**Corrective Action Plan – Soil and Mine Wastes, Revision 1
Three Kids Mine
Lakemoor Ventures LLC**

Re: Corrective Action Plan – Soil and Mine Wastes, Revision 1
Three Kids Mine

Appendix A	Three Kids Mine Remediation and Reclamation Act
Appendix B	Response to Comments
Appendix C	Asbestos Abatement
Appendix D	Corrective Action Schedule

Figure 1-3

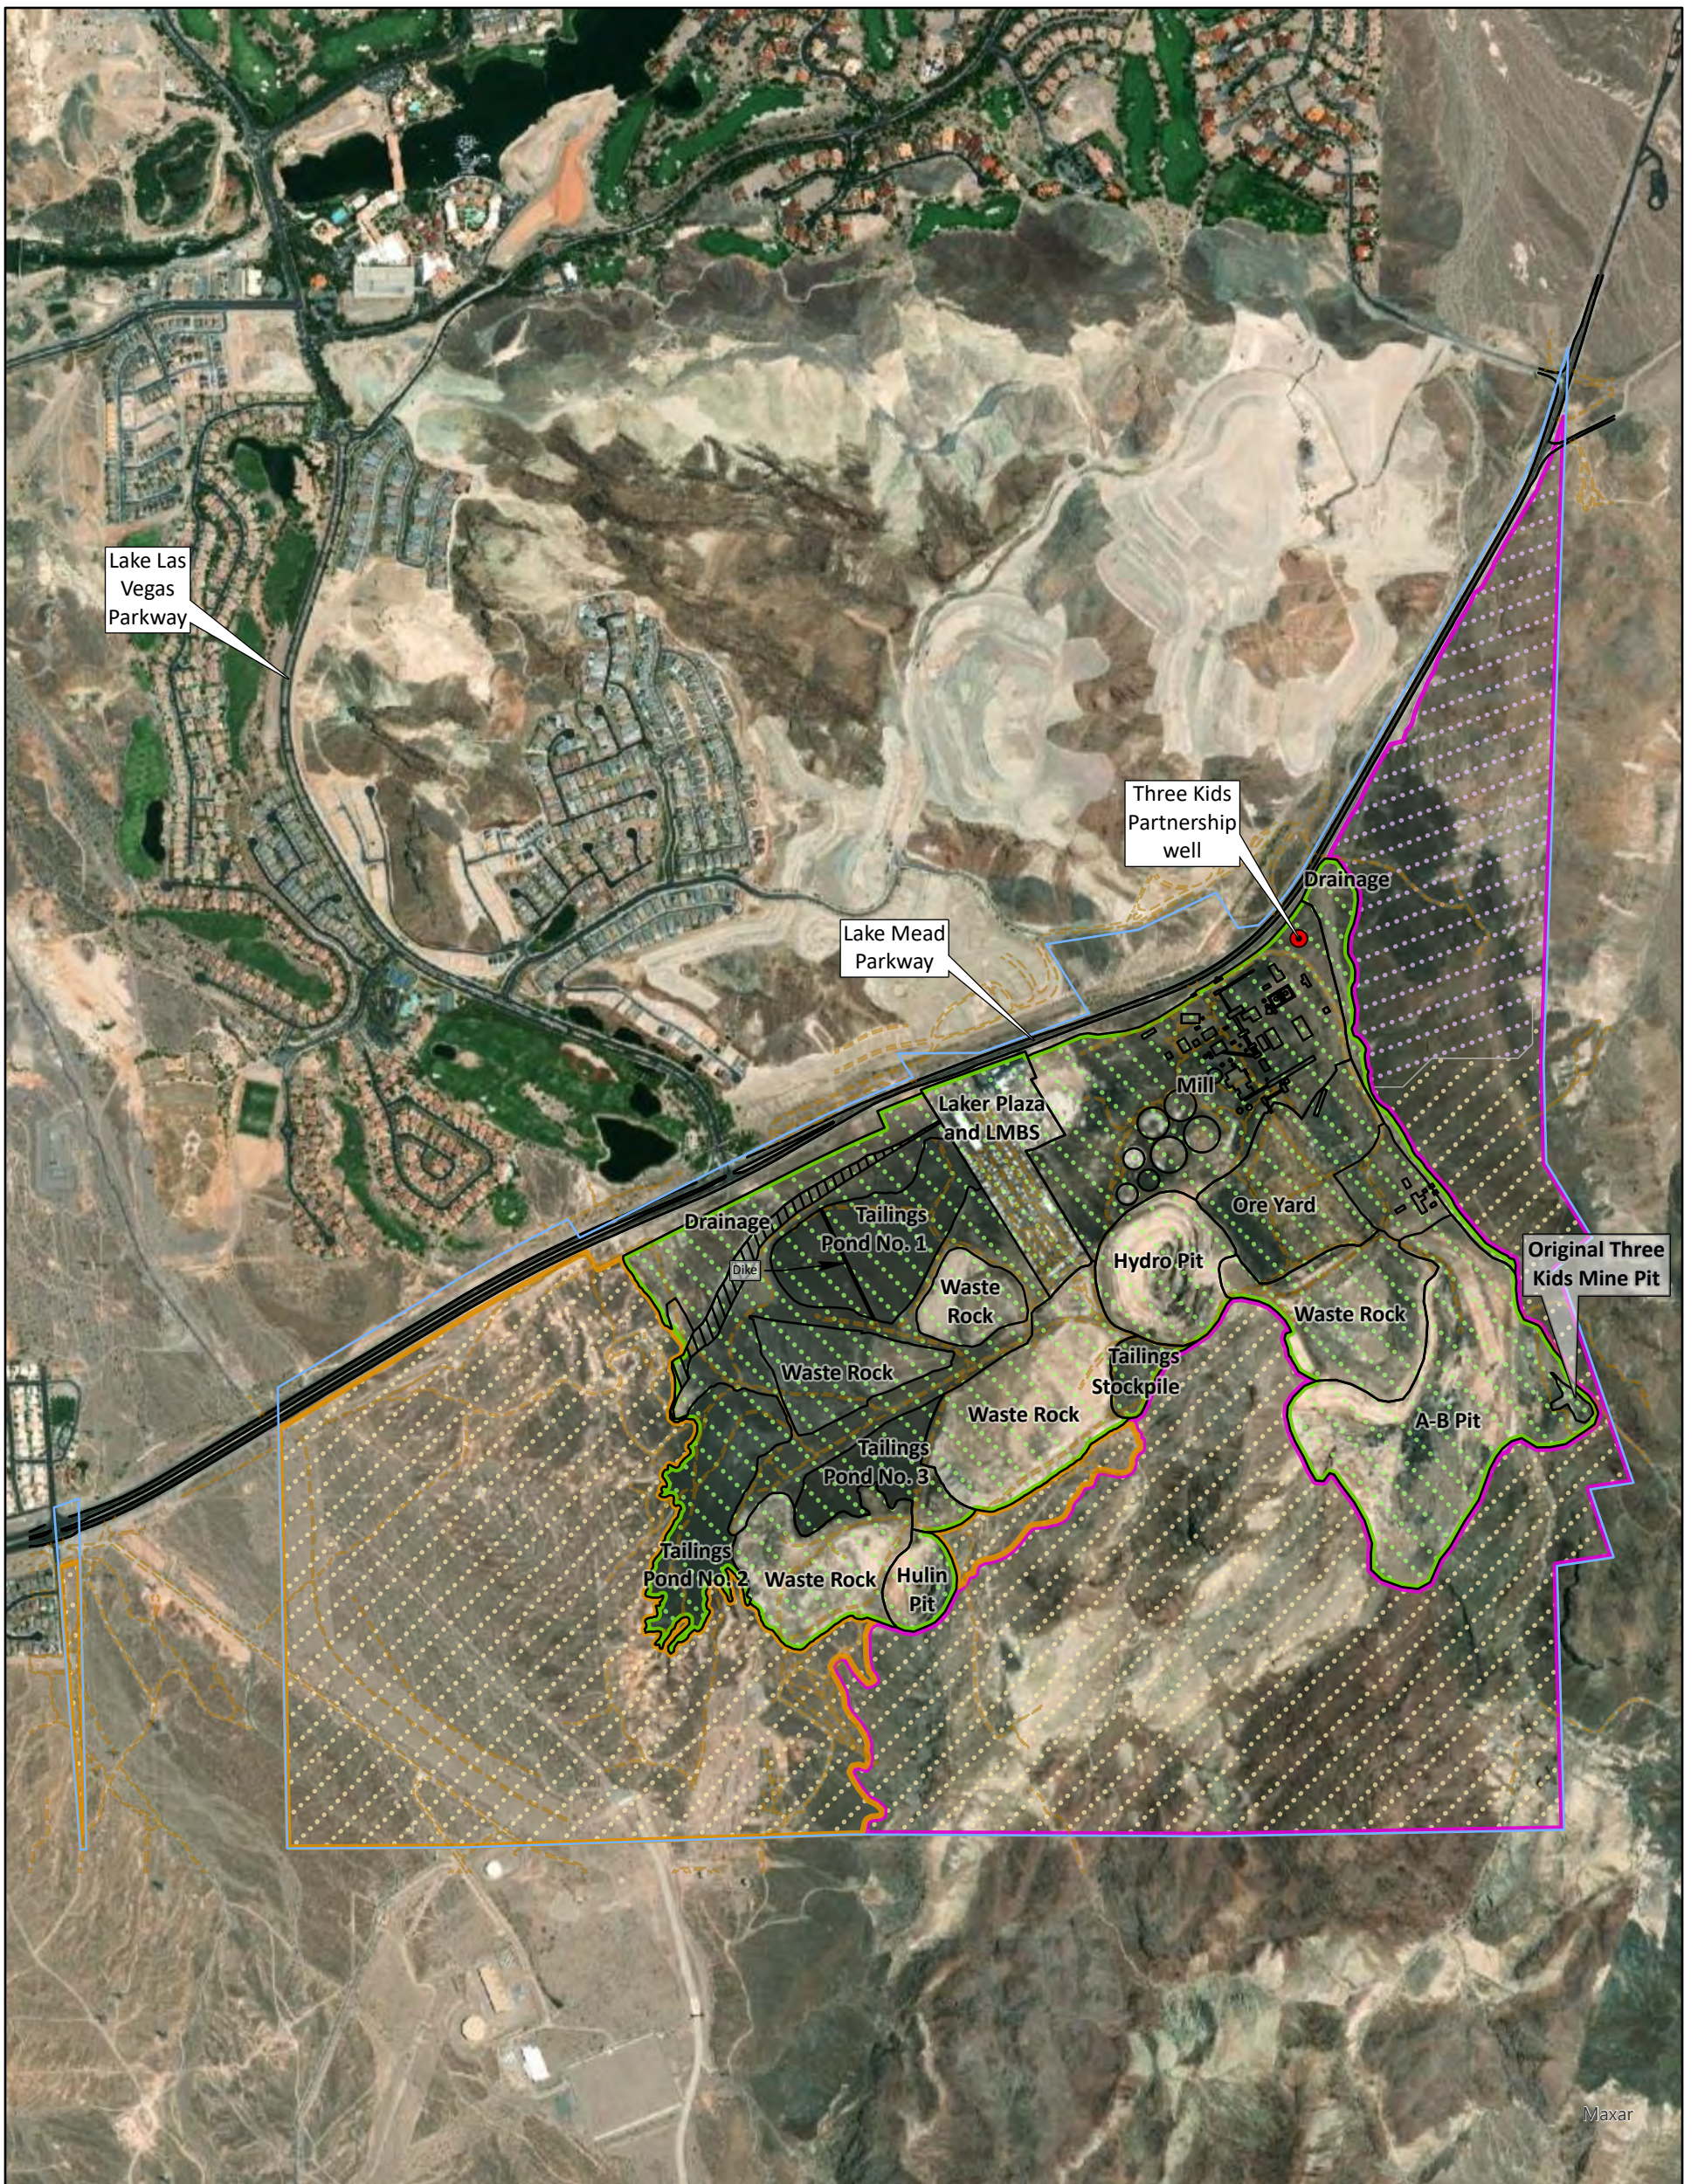
8. **Section 1.1 Site Location and Description** – The second paragraph defines the size of the disturbed, impacted, and undisturbed areas. Please superimpose each of these areas on Figure 1-2 or include an additional figure to identify them.

The disturbed former mine site, the area evaluated for potential impacts from windblown sediments (received a no further action determination from NDEP), and the undisturbed/background areas are depicted in Figure 1-3.

Figure No. 2-1
RACM Locations

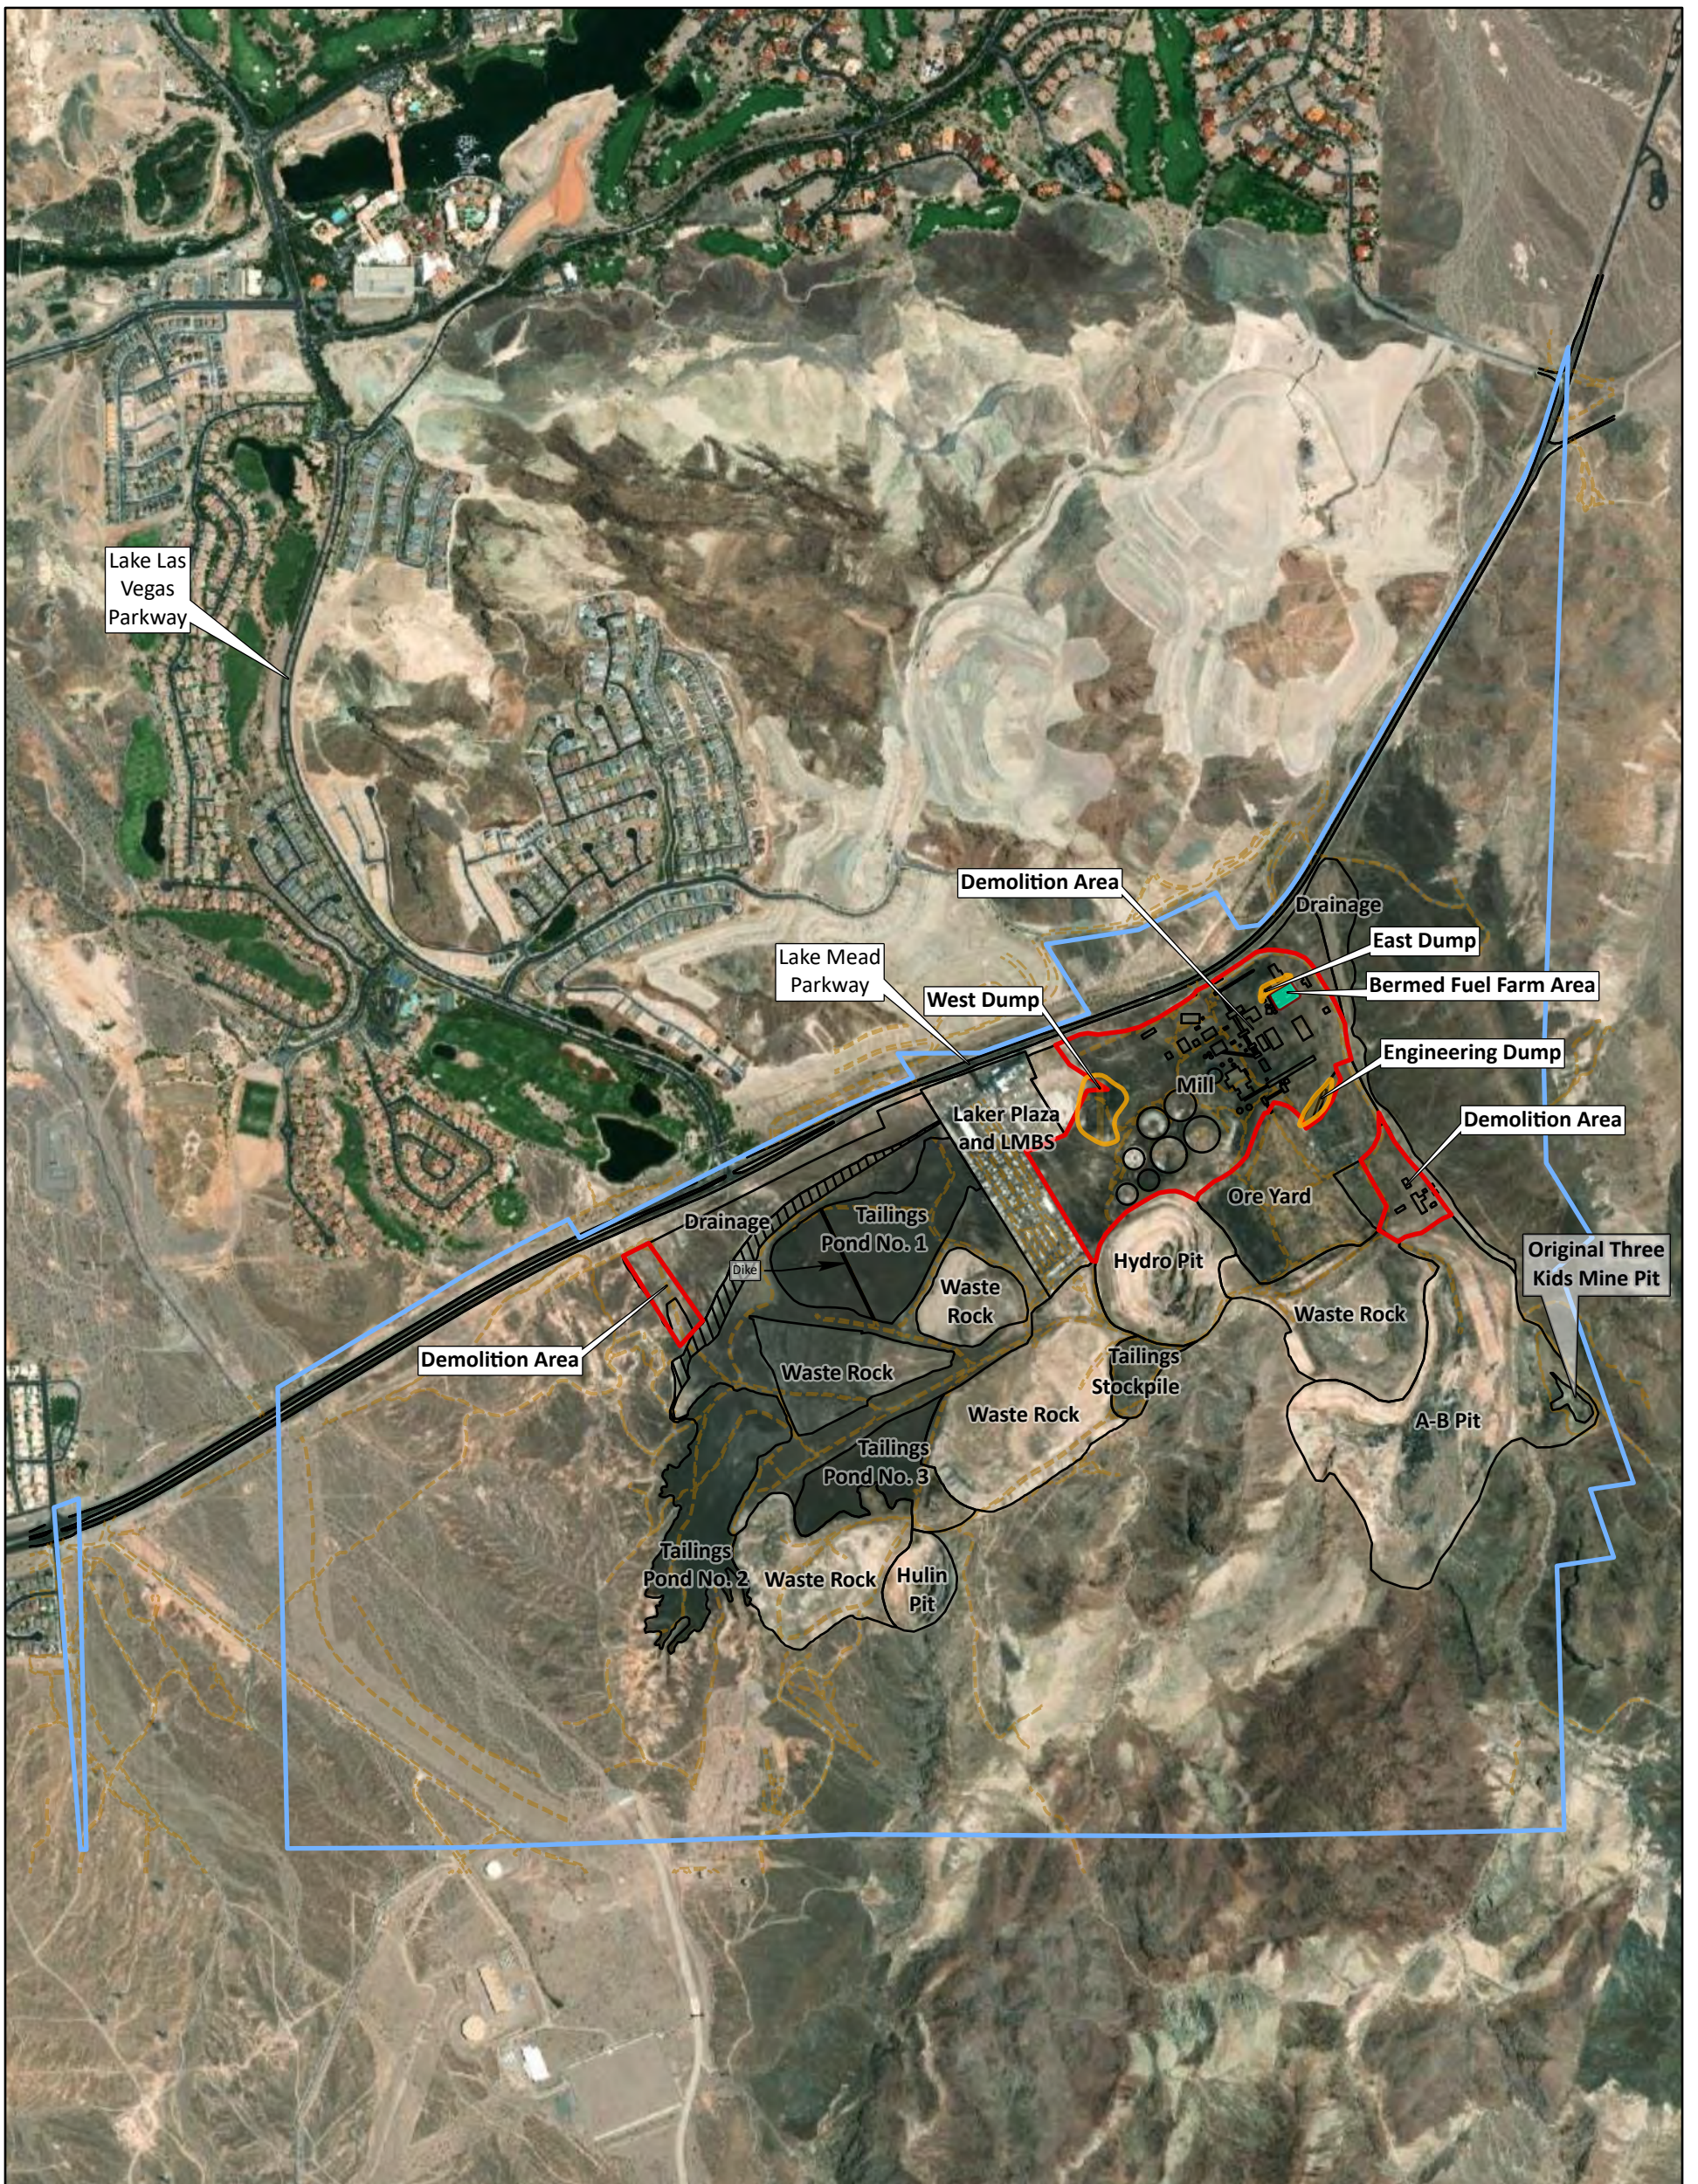
16. **Section 2.1 Summary of Asbestos Work Performed** – This section states that “Figure 2-1 depicts the boundaries of the sixteen sample areas that were established as documented in the Asbestos Survey Report” and that “Figure 2-1 depicts the approximate location of the RACM identified at the Site.” However, Figure 2-1 is not included in the CAP. Please include Figure 2-1 in the CAP.

Figure 2-1 is included in the revised CAP.

Figure 5-3

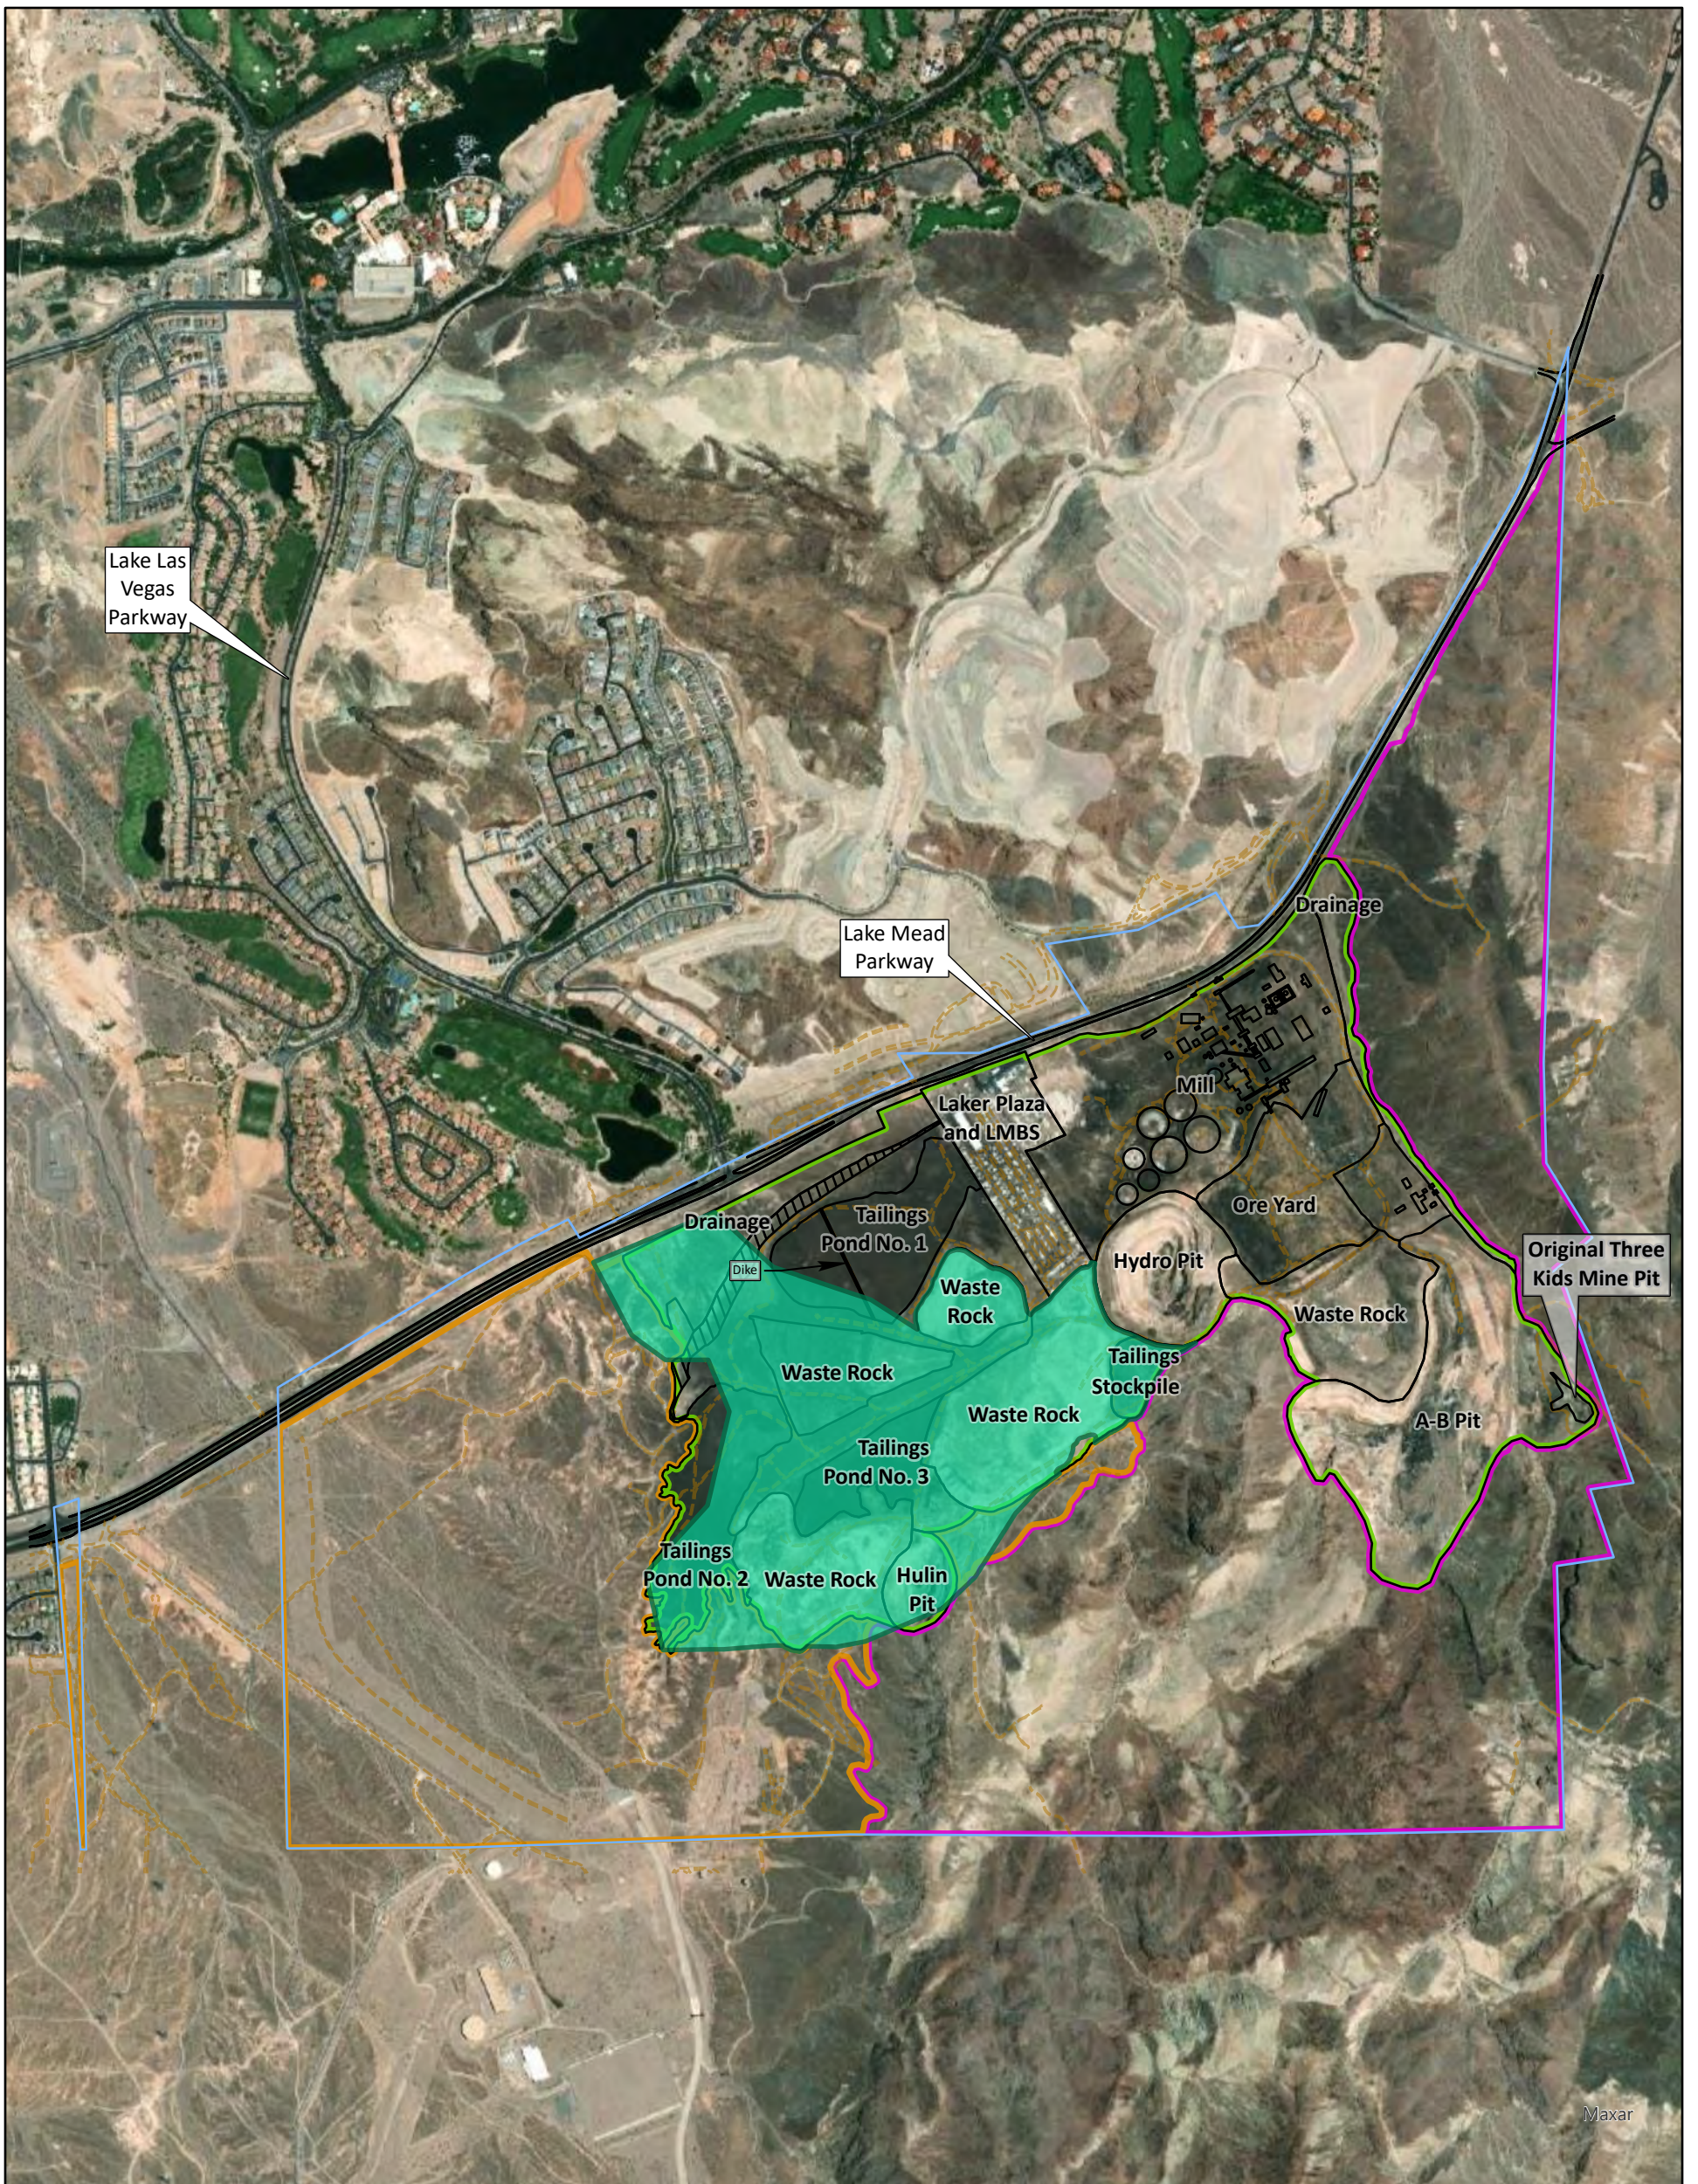
44. **Figure 5-3 Placement of Excavated Material in Hydro Pit** – The two dump locations and the color interpretation of the access road in Figure 5-3 are difficult to interpret. Please revise for clarity.

Figure 5-3 was revised to more clearly show the two dump slopes in the Hydro Pit.
